UNITED STATES PATENT AND TRADEMARK OFFICE

Office Action Summary

10/600,379

DETAILED ACTION

Patent 5697320 (see marked-up figures below).

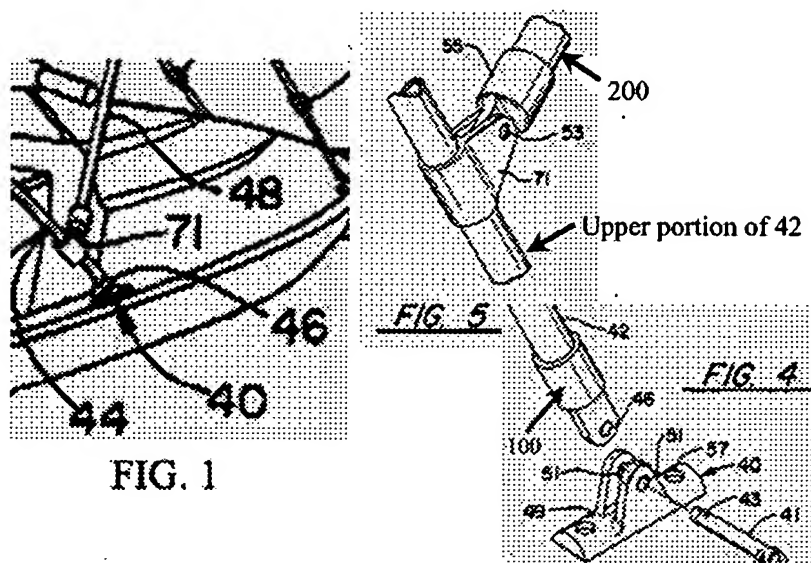
Claim 1. Murray discloses (figs. 1, 4, 5) a variably positionable coupler mountable on a curved surface, comprising: a base (40) formed with an upper side and a lower side, wherein the lower side is a substantially flat planar surface; means (57) for mounting the base on the curved surface (curved surface of the watercraft as seen in figure 1); a tub (100) adjustably connectable to the base; a plug [42 (including upper portion of 42) and 71] repositionably attachable to the tub; a neck (55) rotatably insertable in the plug [42 (including upper portion of 42) and 71], wherein the neck is formed for securing a shaft (200) to the neck; and a clevis mechanism (clevis

connection between 55 and 71) slidably and demountably engageable with the plug and the neck. (Note that while the Murray curved surface does not curve at its point of contact with element 40, it does curve elsewhere and is thus a curved surface within the broadest reasonable interpretation of the claim language).

Claim 2. Murray discloses opposing yokes (tab portions of 40 receiving 41) monolithically extending at substantially right angles from the upper side of the base.

Claim 3. Murray discloses one or more bores (51) formed in the base with a proximal end and a distal end, and further wherein the one or more bores are shaped for removable engagement with a bolt (41). The word "bolt" is taken by the Examiner to mean, "a metal rod or pin for fastening objects together" in accordance with Merriam-Webster's Collegiate Dictionary Tenth Edition.

The Applicant argues that element (55) of Murray cannot be the neck since the Examiner has already identified element (55) as being tub (100). This is not persuasive. The marked-up drawings clearly show that the Murray tub (100) and Murray neck (55) are two separate elements.

The Applicant argues that the Murray neck (55) is not insertable in the plug. This is not persuasive since the marked-up figures clearly show a plug [42 (including upper portion of 42)

and 71] repositionably attached to the tub (100); a neck (55) rotatably inserted in the plug [42 (including upper portion of 42) and 71].
